**LINCOLN CITY/LANCASTER COUNTY PLANNING STAFF REPORT**  
**for May 26, 2004 PLANNING COMMISSION MEETING**

**P.A.S.#:** County Change of Zone #04030  
Red Cedar Ridge 1<sup>st</sup> Add Pre. Plat #04015

**PROPOSAL:** Lyle Loth, ESP, for Alan Baade, has requested a Change of Zone and Preliminary Plat to create 35 lots on property generally located at S. 82nd and Roca Rd.

**DATE:** May 4, 2004  
**TO:** Mike DeKalb  
Planning Department  
**FROM:** Larry V. Worrell   
County Surveyor  
**SUBJECT:** RED CEDAR RIDGE

**Preliminary Plat #04015  
Change of Zone #04030  
Red Cedar Ridge  
S, 82nd & Roca Rd.**

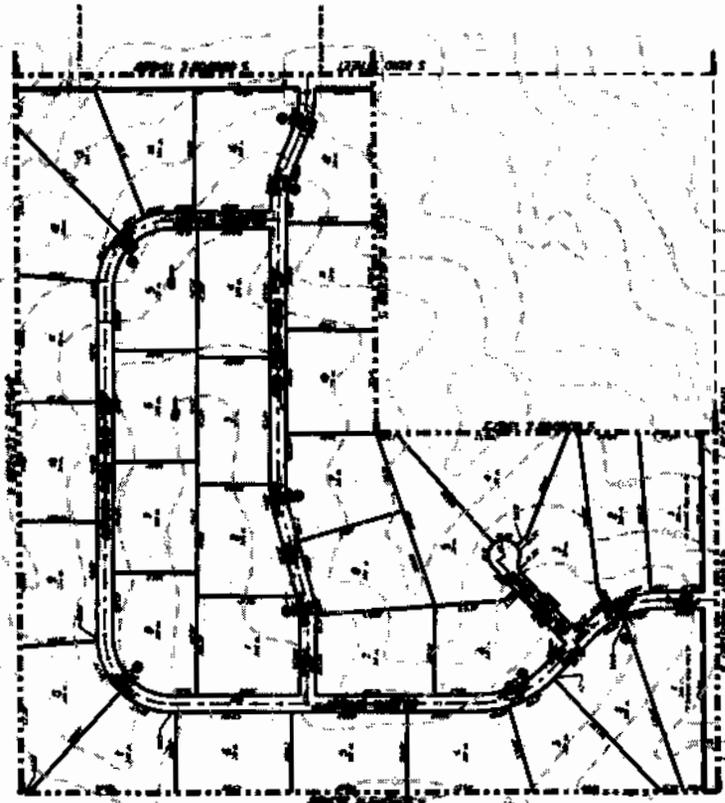
- 1) There should be a note on the Preliminary Plat and on the dedication on the Final Plat that "lots will be permitted one residential access only".
- 2) Developer will be responsible for Installation of all traffic control devices and street identification signs as noted in *General Note 12* plus two speed limit signs.

- 8) Access to South 75<sup>th</sup> Court from Lots 4 and 5 will be very difficult due to the high fill of the cul-de-sac.
- 9) *General Note 5* indicates that the streets are private; however, the drawing does not show this.

- 1.2.1 Remove City of Lincoln from Note # 3.
- 1.2.2 Correct Note #5 to clarify that the roads are public or private.
- 1.2.3 Provide a Planning Commission acceptance block and remove the City of Lincoln acceptance block.
- 1.2.4. Show Block numbers
- 1.2.5 Revise Note #8 to reflect S. 82<sup>nd</sup> Street
- 1.2.6 Revise Note # 10 to include block length
- 1.2.7 Show a date prepared on the sheets.
- 1.2.8 Show a typical street cross-section.
- 1.2.9 Explain or revise Note #13.
- 1.2.10 Show a street connection to the boundary of the plat, including to the 80 acres at the intersection of Roca Road and S. 82<sup>nd</sup> Street.

RED  
CEDAR  
RIDGE  
PRELIMINARY  
PLAT

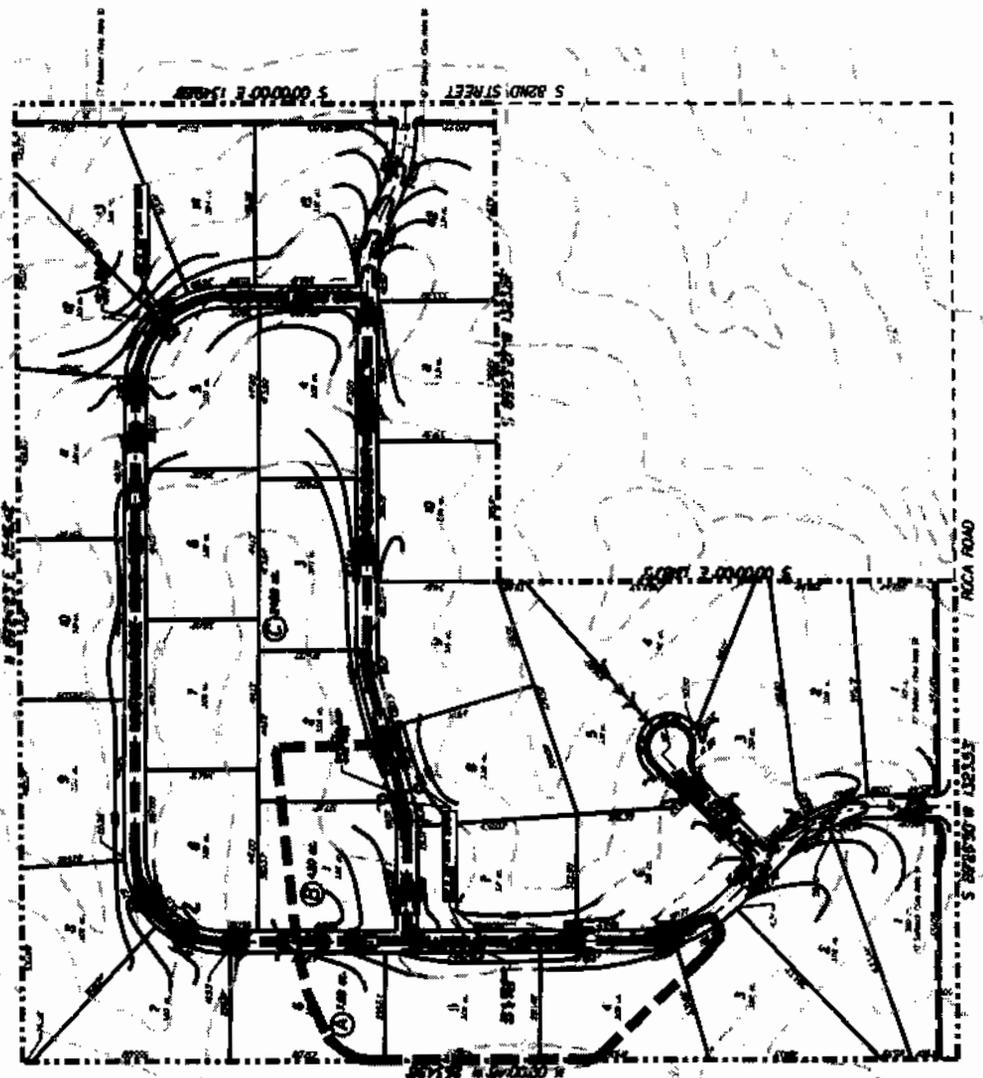
- 3) The profile of South 75<sup>th</sup> Street at Roca Road and the profile of Red Cedar Road at South 82<sup>nd</sup> Street must have a vertical curve where the break in grade is shown.

- 5) It appears that the 30" culvert and the 42" culvert do not have enough fill over the pipe to keep water from going over the road.
- 6) Red Cedar Road should be moved approximately 80.00 feet south to provide adequate sight distance for the intersection.

- 7) The profile of Roca Road is not correct. This will affect the profile of South 75<sup>th</sup> Street as it connects to Roca Road and the sight distance drawings.

- 10) The intersection radius at the intersection with Roca Road and South 82<sup>nd</sup> Street will be 50.00 feet.
- 11) *General Note 8* shall allow for access to South 82<sup>nd</sup> Street from Red Cedar Road and for access to Roca Road from South 75<sup>th</sup> Street.
- 12) Grading shall extend around all cul-de-sacs.
- 13) A typical section shall be shown for the road grading.
- 14) Roads shall be constructed to Lancaster County Standards. All improvements shall be complete prior to Final Plat approval.
- 15) The Acceptance Note refers to the City of Lincoln which is incorrect.
- 16) The plat boundary should not go to section line on the south side. Lot 4, Irregular tracts, does not include the road right-of-way on Roca Road.
